SERVICE BULLETIN No. 10

Replacement of oil pressure sender

Applies to Sinus/Virus/Virus SW aircraft.

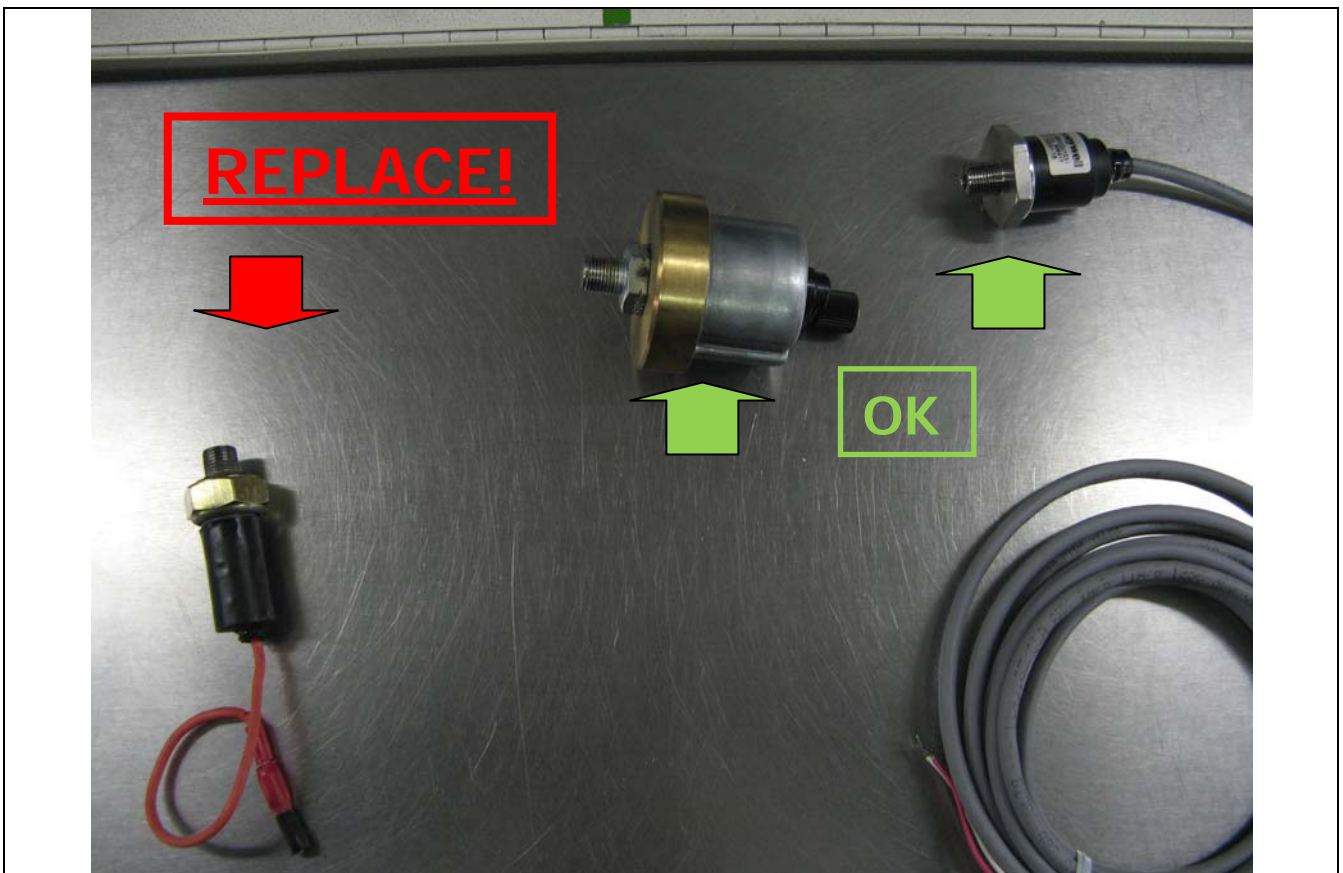
There was a reported case of oil leaking through the oil pressure sender on a Virus 912. Upon closer investigation it became apparent that the specific oil pressure sender (digital – switch type) is not reliable over its serviceable life and has a potential to develop an oil leak through the sender head, causing the oil to escape and effectively producing loss of oil pressure in the engine. Due to the potential hazard of engine failure in any stage of flight, we have decided to order replacement of all oil pressure senders of the type in question with immediate effect. Replace the problematic oil pressure sender with the following new sensor:

The required time for replacement of the oil pressure sender is 1 hour. You will only need basic tools and a plastic cable tie. First, identify whether your aircraft has the problematic oil pressure sender. It is possible that it was already replaced for another type during servicing. Use the following photograph for identification:

Rotax Pressure Sensor Assy. PN 956357 (15 Nm / 135 in.lb. torque)

Having identified the oil pressure sender, expose the wire and disconnect the sender wire. Unscrew the oil pressure sender and replace it with the new unit. Reconnect the wire and make sure that the wire

connection (joint) is sealed against contaminants. Cut the existing cable tie, pull out the connector and replace it with a new, good one. Make sure you apply a new cable tie and test for the seal. Before doing this, make sure you have disconnected the battery from the circuit.

Before next flight make sure you have performed the setup for the new sensor also on the Brauniger AlphaMFD multifunction instrument. Go into settings (hold function-set button for 5 seconds), then go to setup page 29 "Oil Pressure Sensor" and change the setting from DIGI to ANA.
